Application No. 10/711,904 Examiner: Shih-Chao Chen

Amendments to the Drawings:

Remarks

Fig. 3

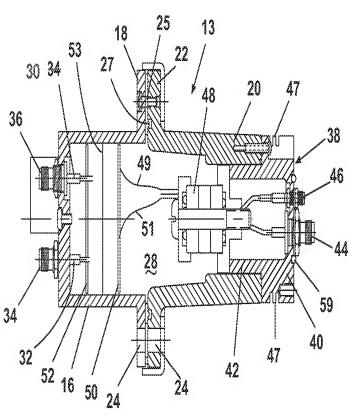
The attached sheet of drawings includes changes to Fig. 3. This sheet replaces the original sheet including Figs. 3 and 4. In Fig. 3, numeral 34 directed to the lead line has been changed to 30.

The drawings stand objected to on various grounds. The objection is traversed. The Examiner asserts that element 34, shown in Figure 3, refers to both the cable lead and the connector. Fig. 3 has been amended to properly reflect the subject cable lead with the reference number 30, as indicated in paragraph [41] of the application.
